# RENESAS TECHNICAL UPDATE

Product Category	MPU/MCU	Document No.	TN-SH7-A899A/E	Rev.	1.00
Title	Clearing of flags upon DTC transfer in RCAN-ET		Information Category	Technical Notification	
Applicable Product	See below.	Lot No.	Reference Document	See below.	
		All lots

We would like to inform you of the correction of errors in the user's manuals listed below. Please refer to the following for details.

Figure 21.14 DTC Transfer Flowchart

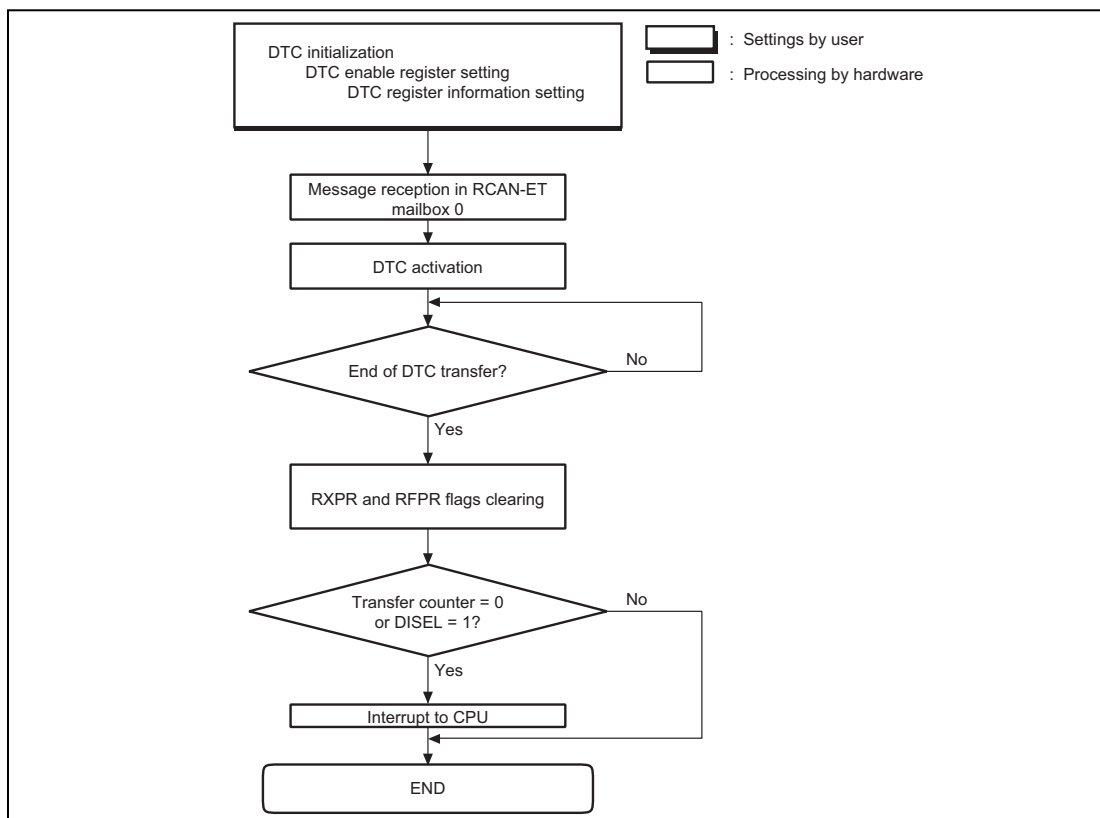
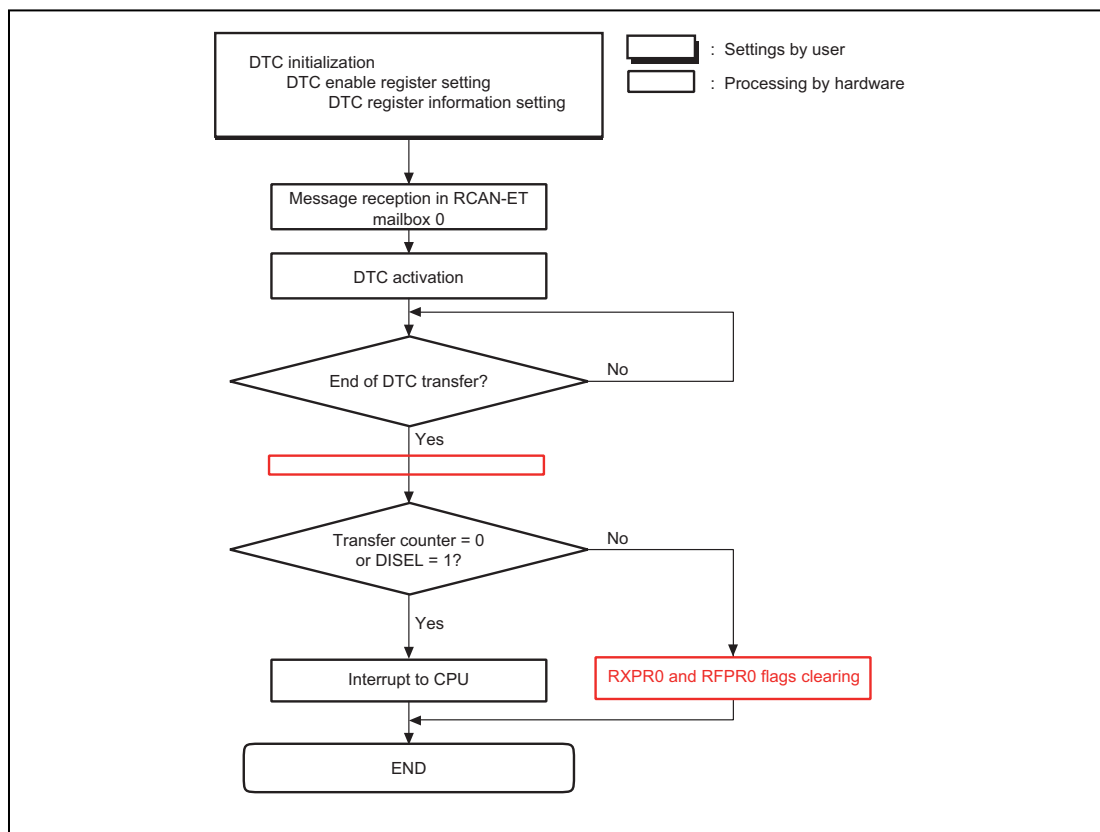
The DTC can be activated by the reception of a message in RCAN-ET mailbox 0. When DTC transfer ends after DTC activation has been set, flags of RXPR0 and RFPR0 are cleared automatically. An interrupt request due to a receive interrupt from the RCAN-ET cannot be sent to the CPU in this case. Figure 21.14 shows a DTC transfer flowchart.

The DTC can be activated by the reception of a message in RCAN-ET mailbox 0. When DTC transfer ends after DTC activation has been set, flags of RXPR0 and RFPR0 are cleared automatically (except when the transfer counter = 0 or DISEL = 1). An interrupt request due to a receive interrupt from the RCAN-ET cannot be sent to the CPU in this case. However, when the transfer counter = 0 or DISEL = 1, an interrupt is sent to the CPU. Figure 21.14 shows a DTC transfer flowchart.
